## Product/Process Change Notice - PCN 22\_0048 Rev. -

**PCN Title:** Addition of ASE Korea as an Alternate Assembly Site for Select LFCSP Products

**Publication Date:** 19-Apr-2022

# BOM CHANGE SUMMARY

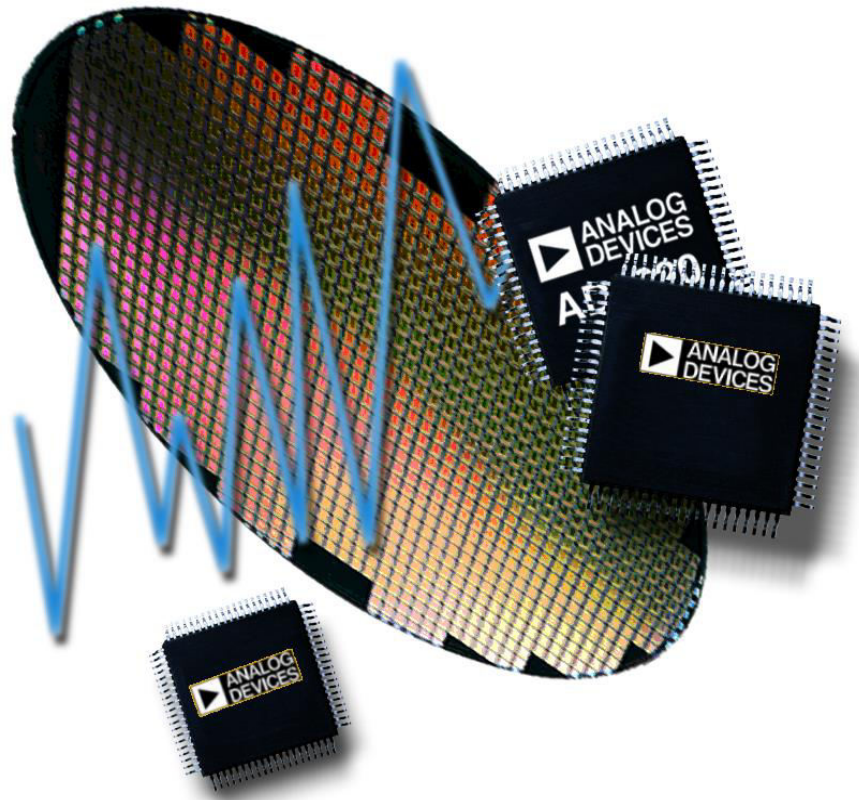
- ▶ From 4 BOM at UG1 to 1 BOM at AEK.
  - 4 different Adhesive material at UG1 will become 1 Adhesive material at AEK

Assembly Site	From - UNISEM Malaysia (UG1)	To - ASE Korea (AEK)
Wire	Au/1.0	Au/1.0
Die Attach	<b>Ablestik 2815A conductive</b> <b>Hysol QMI 519 conductive</b> <b>Sumitomo CRM 1076NS conductive</b> <b>Sumitomo CRM 1076DJ conductive</b>	Hitachi EN 4900GC conductive
Mold Compound	Sumitomo G770HCD	Sumitomo G700LYT
Plating	100Sn	100Sn
